JOINT FEDERAL/STATE APPLICATION FOR THE ALTERATION OF ANY FLOODPLAIN, WATERWAY, TIDAL OR NONTIDAL WETLAND IN MARYLAND

USACE Comment	MDOT SHA Response
	The Corps appreciates the opportunity to comment on the Draft JPA for I495 MLS. We found files well organized and easy to access, and the mitigation tables were particularly helpful. After review, additional discussions are needed regarding details of impacts for some locations and opportunities for additional avoidance and minimization. Additional comments will be provided after receipt of the final JPA. Our six major comments are:	
	1 More detail is needed regarding bridge alternatives (Impacts, sequence of construction, etc.) regarding work at the American Legion Bridge. Some details are provided in Appendix G NPS SOF of the Draft EIS, and the Corps would like to discuss refined options in further detail. ALB impacts and approaches will be considered in review of the final JPA.	Please refer to the Avoidance, Minimization, and Impacts Report Section 2.2.1, included in the Revised JPA package for a more comprehensive summary of the alignments considered in the vicinity of the ALB. Sequence of constructions and design details are no

Mainline Impact Plate 5

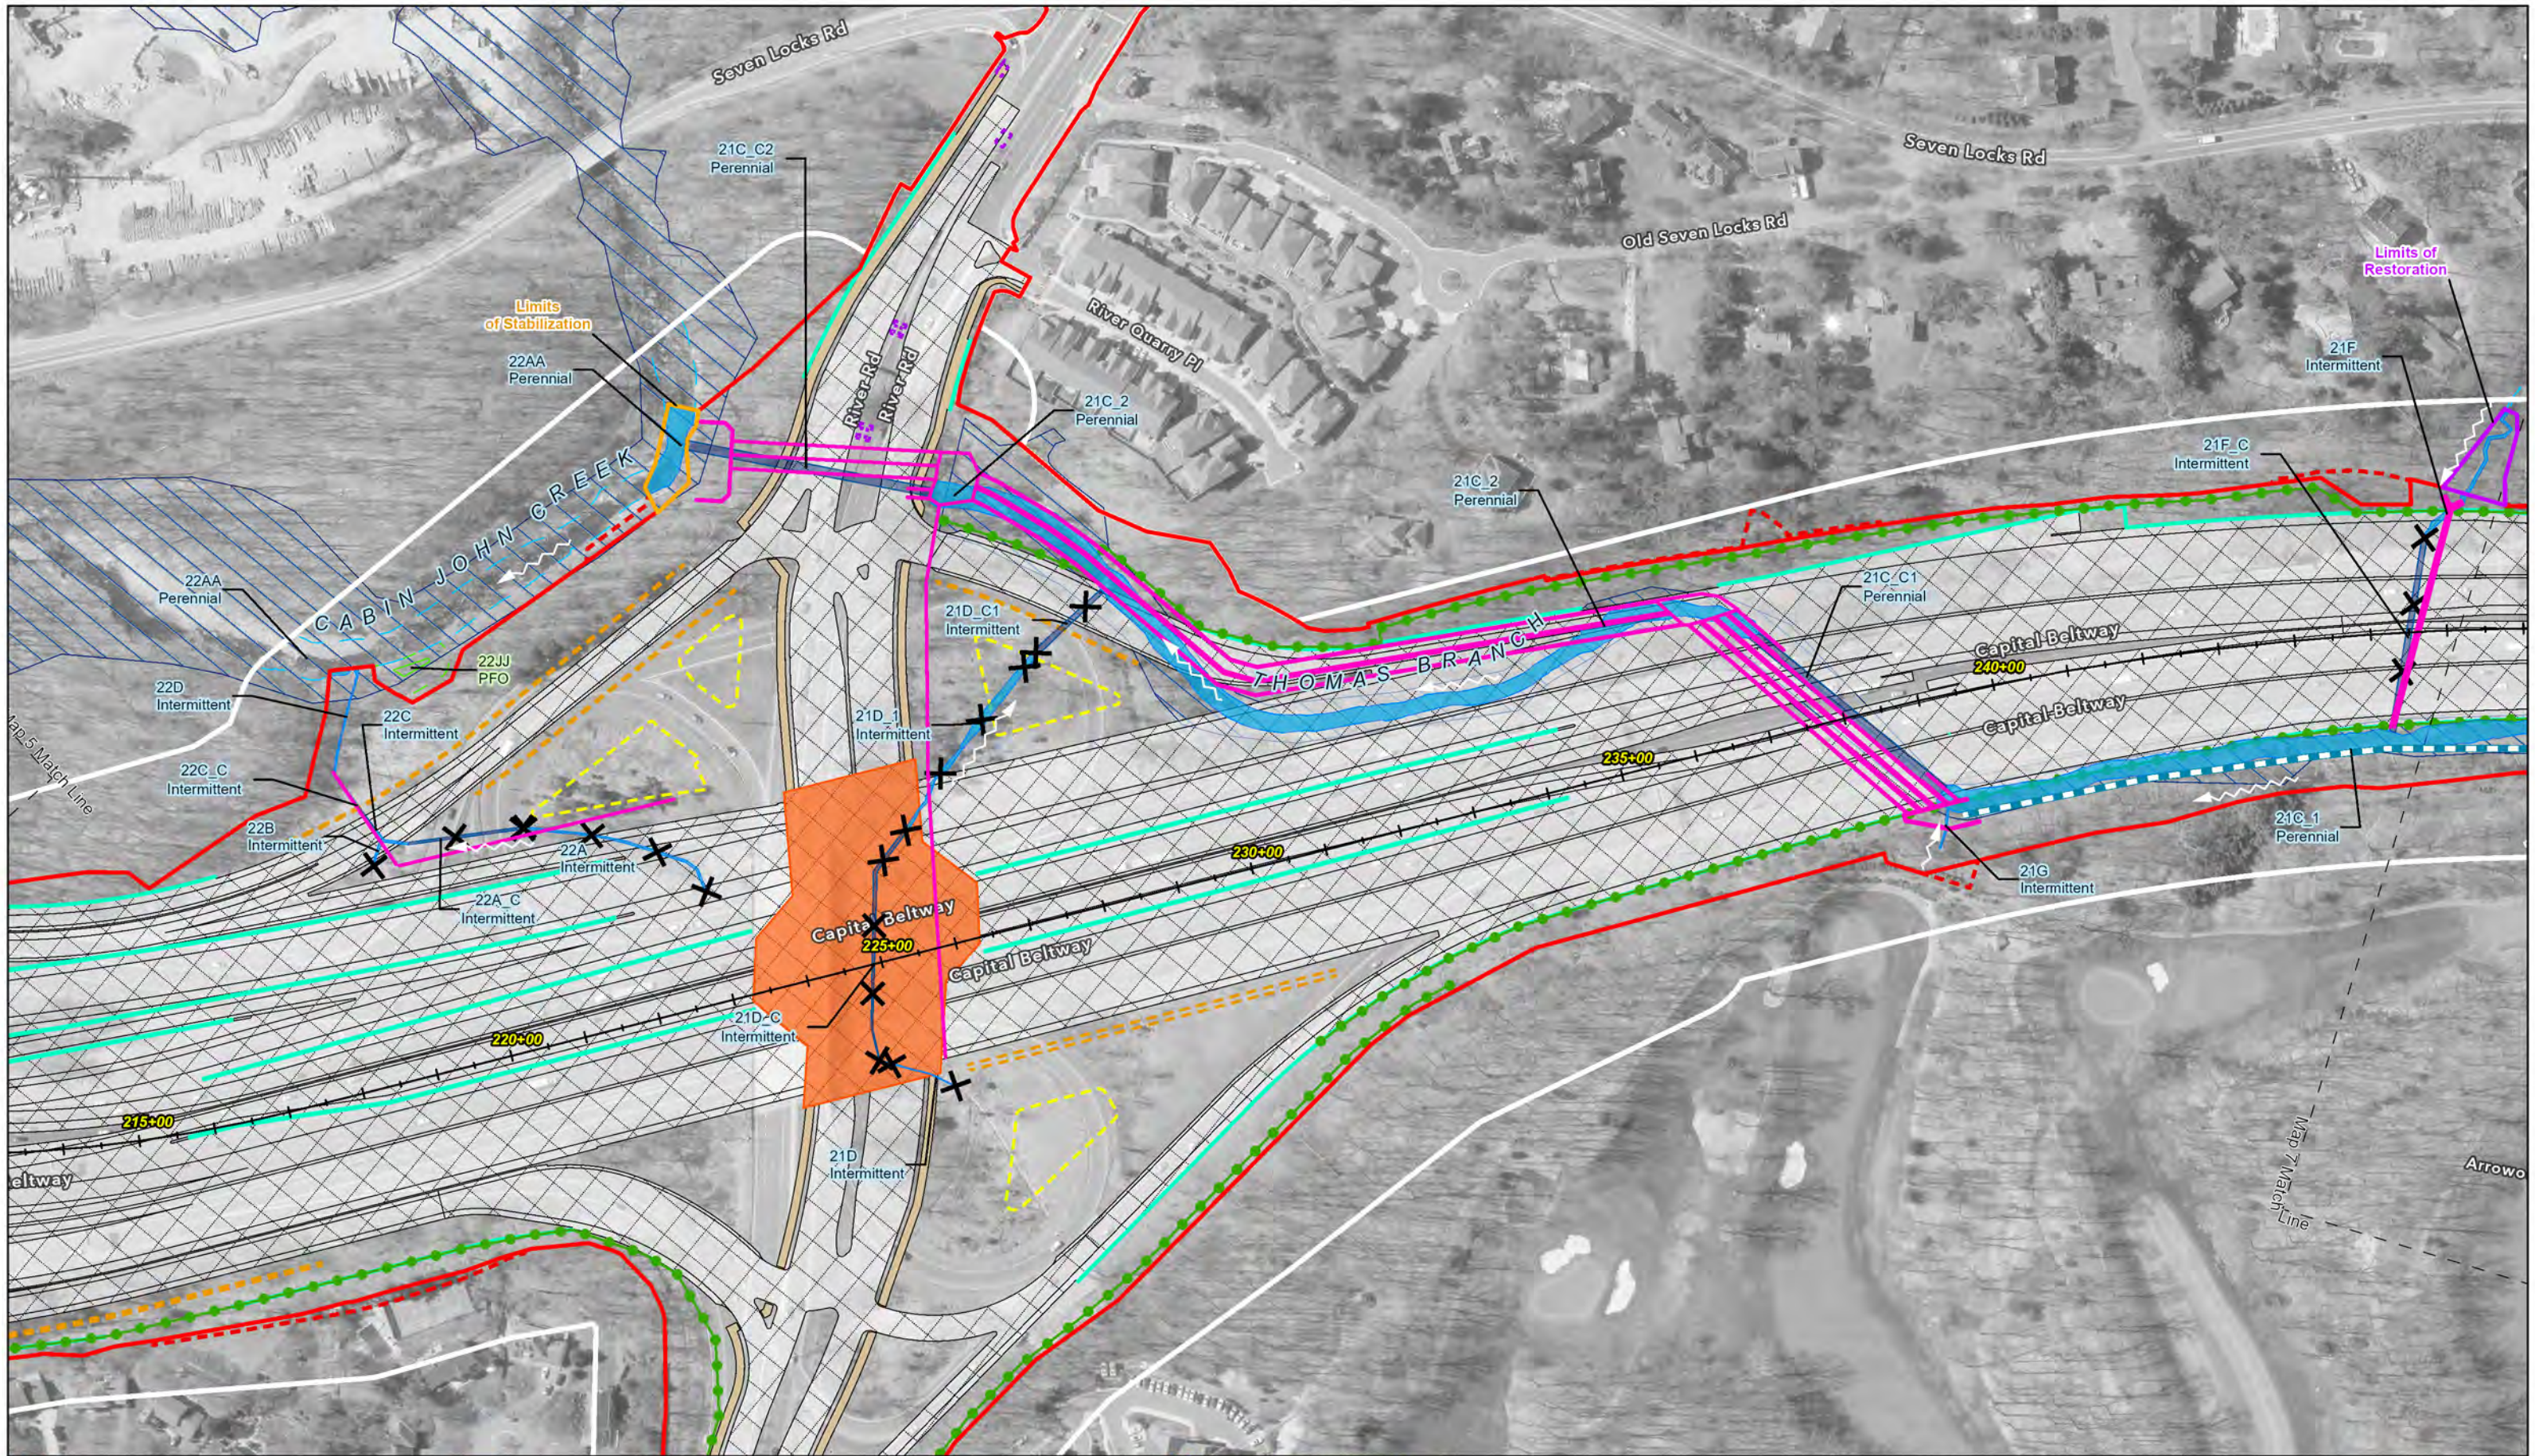
13	Impact Plate 5 and 16	Regarding placement of noise barriers, please consider avoidance and minimization of wetland buffer impacts to 22GG and 26H. Also, please clarify the noise wall location in the area of 26H. The FEIS shows a noise wall within the buffer of 26H, while the JPA Impact Plates do not.	22GG will be eliminated by roadway fill and construction, therefore a SWM swale and vault are proposed to capture the flow previously captured by 22GG. The noise barrier is a secondary cause of impact while the roadway fill and construction are the primary impacts. 26H and its buffer will be impacted by roadway construction access and impacts have been minimized to the extent possible, the noise barrier is not causing the impacts to 26H. The proposed noise wall locations will be consistent between Appendix E and the final JPA Impact Plates.
14	General, Impact Plates	There are several areas between the FEIS Appendix E and the JPA Impact Plates where proposed noise barrier locations do not match. Please ensure the proposed noise walls match between these two documents as appropriate. For example, a proposed noise barrier is shown over 22AA_B1 on Map 8 of FEIS Appendix E, but is not shown in this area on the JPA Impact Plates. Barrier 495 MD-6/6A/7 is labeled as new barrier on App E/pg 4 but does not appear on IP 6/7, STA 232+00 - 247+00, RT. 21C_1 Perennial is in this area. Barrier 495 MD-5 is labeled as 'Existing to be Replaced' on App E/pg 5 but listed as 'Proposed' on IP 7/8, STA 262+00 - 292+00, LT. Thomas Branch is in this area. Barrier 495 MD-8 is labeled as 'Existing to be Replaced' on App E/pg 6 but listed as 'Proposed' on IP 8/25, STA 320+00, RT. 21_B Perennial is in this area.	The FEIS and JPA mapping elements differed due to the time at which the drafts were released. FEIS Appendix E and the JPA Impact Plates show the same noise barrier locations in the final versions.

Mainline Impact Plate 14

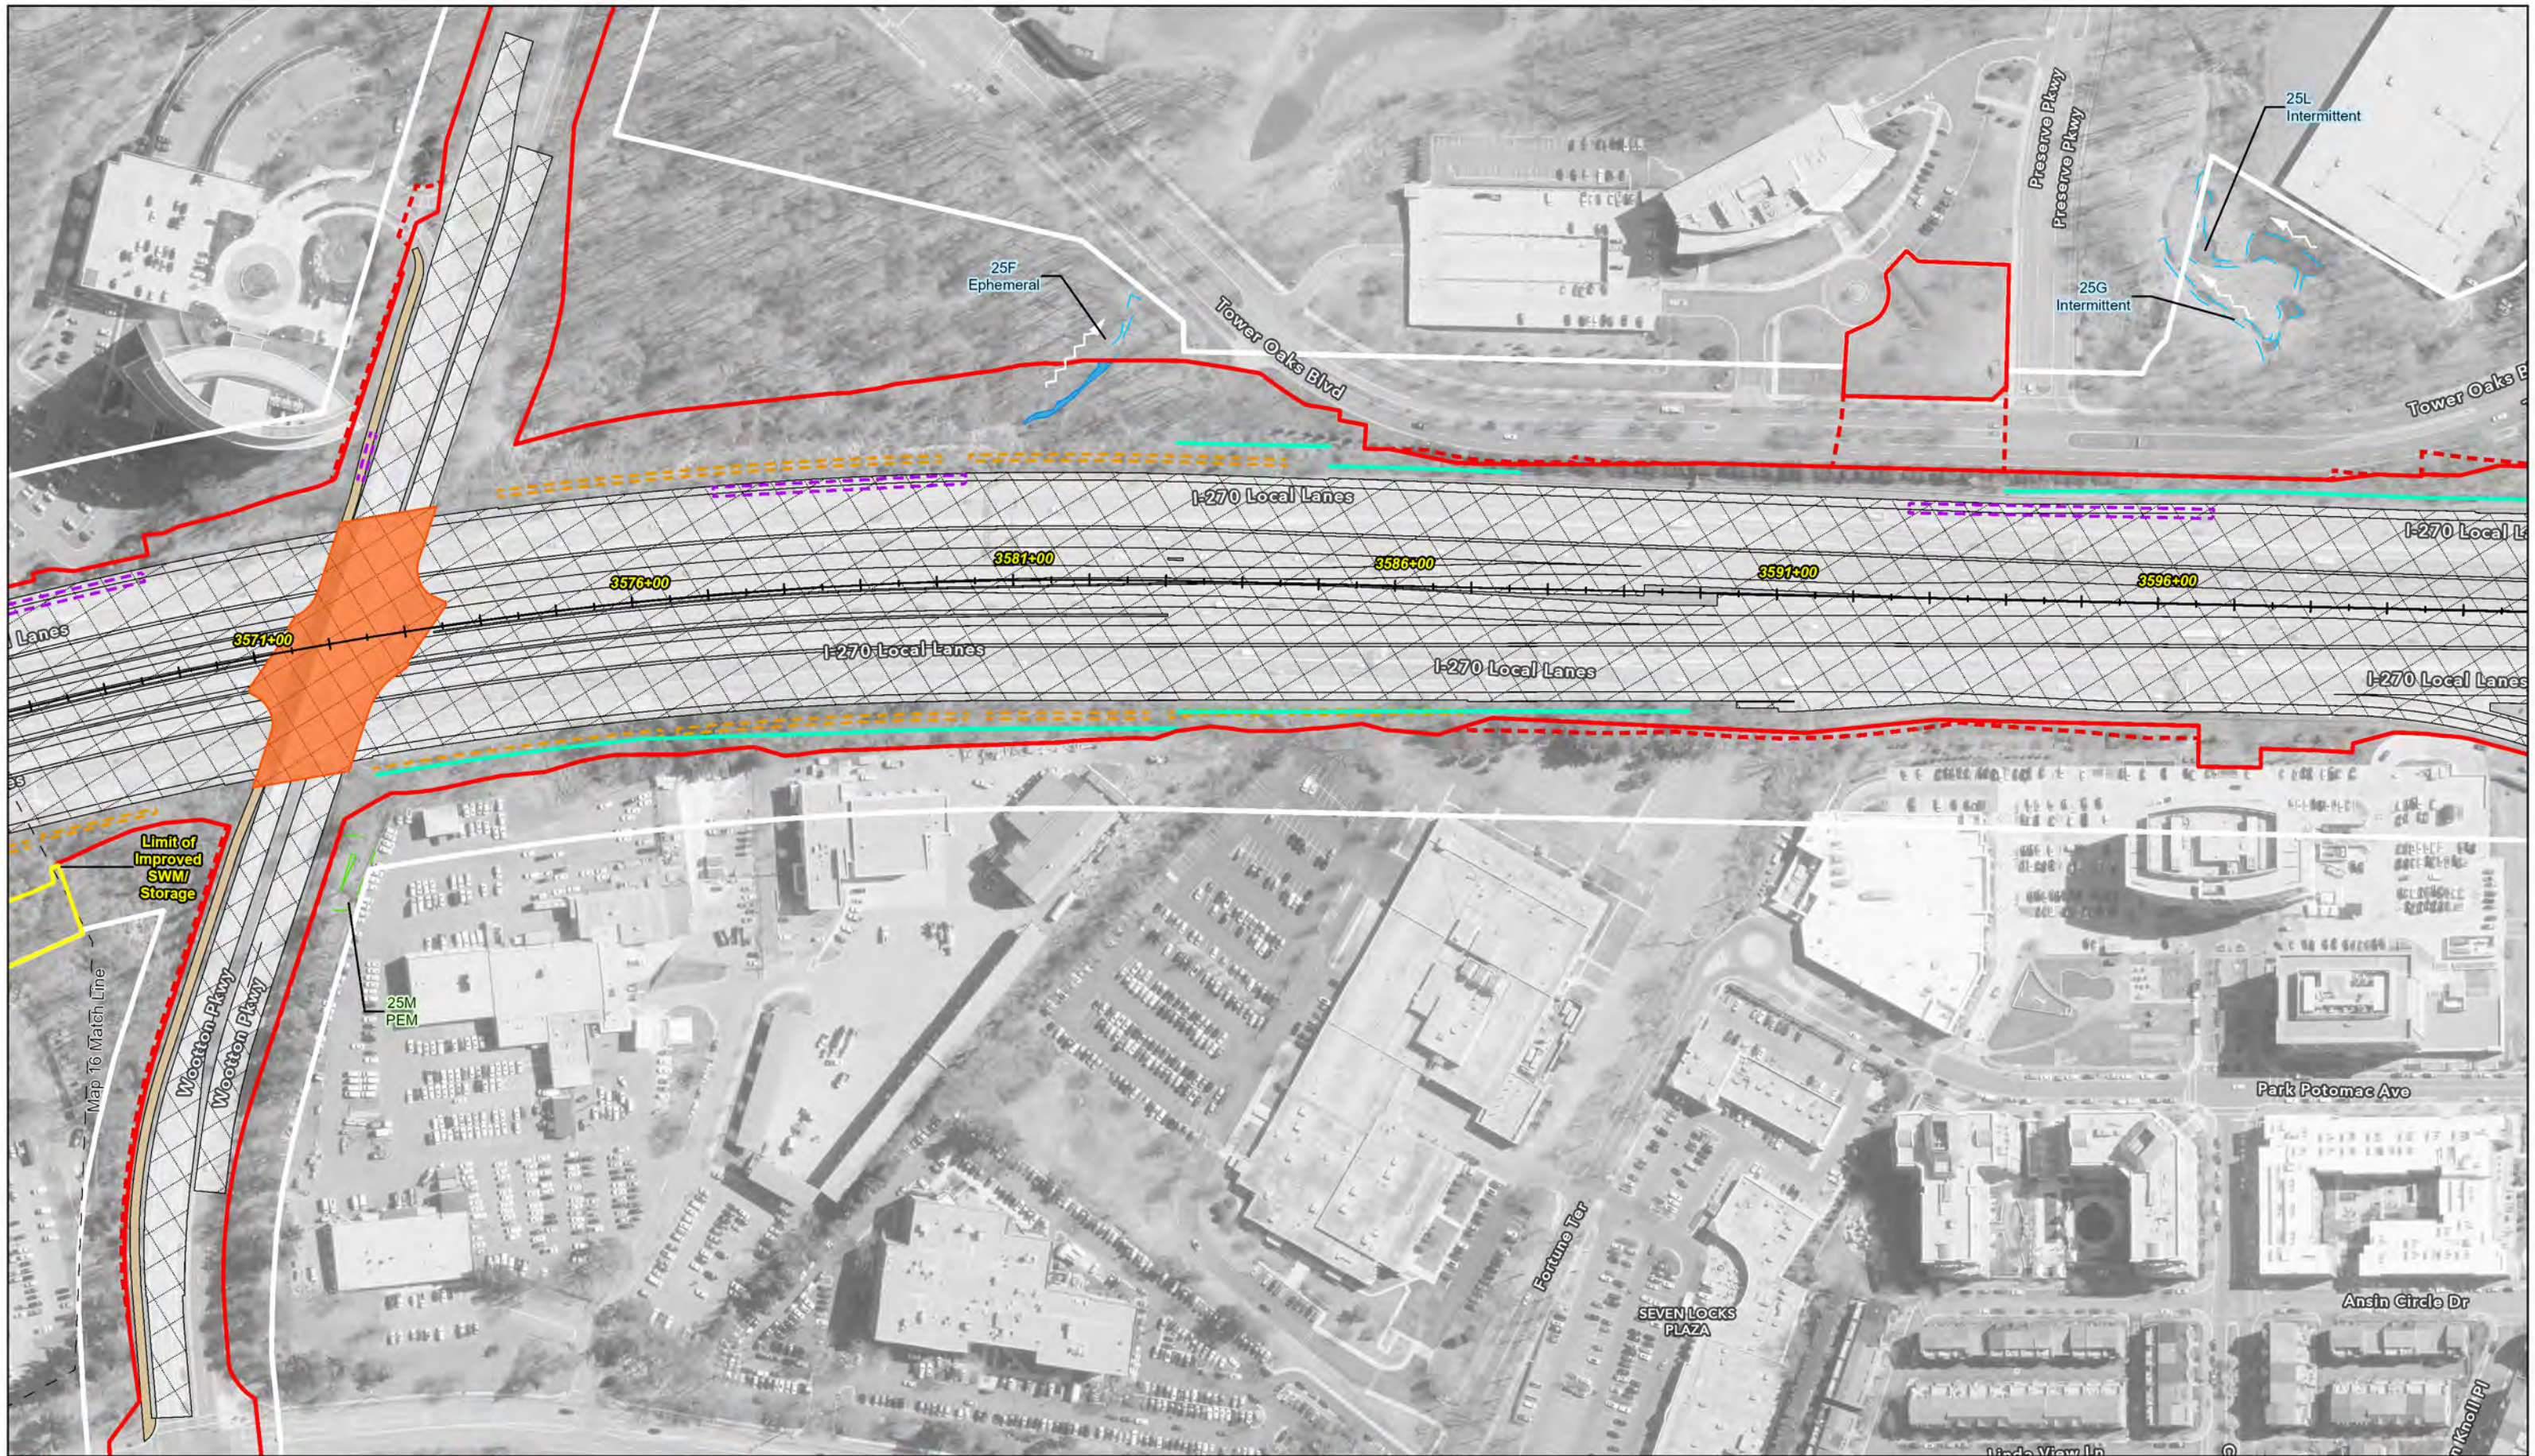
32	AMR Section 3.5.14.A	Please note, the ephemeral waterway 24S is not shown on Impact Plate 14.	Feature 24S was discarded on 10/22/21 as an ephemeral, rip-rap manmade ditch excavated in and draining uplands.
33	AMR Section 3.5.17.B	Please include the small segment of intermittent waterway 26L and intermittent culvert 26C_C1 in the narrative for section 3.5.17.B.	These features have been added to the text.
